SERVICE INFORMATION BULLETIN

APPLICABILITY: 2015-2020MY Outback
 2014-18MY Forester

NUMBER: 15-239-19

SUBJECT: Cargo Net Attachment Hardware Change

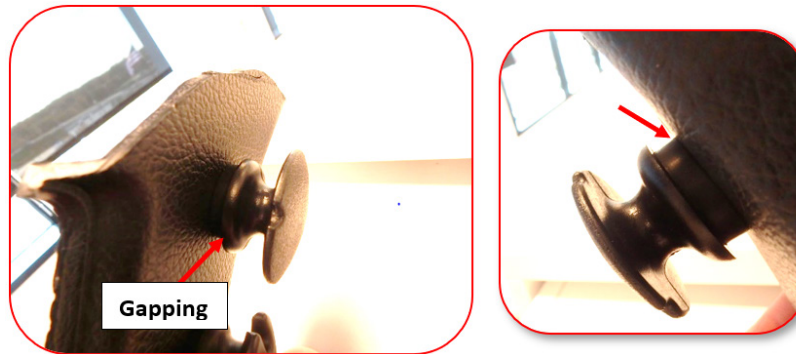
This Service information bulletin announces a design change made to the Cargo Net – Rear Replacement Hardware Kit (F551SAG301). The new part number is F551SAN010. The change was made to address concerns regarding the “mushroom” anchors either pulling out of the trim panel and / or gapping visibly at the base of the anchor (between the black plastic spacer and trim panel) as shown in the photos below.

The images below show the differences between the new and old-style mushroom anchors including:

- Overall diameter of the new-style part is smaller with increased size notches to more easily secure the cargo net’s elastic loops

- The length of the well nut has been increased and the spacer (washer) is now integrated for better retention in the trim panel.

The part number for the new replacement hardware kit is **F551SAN010**.
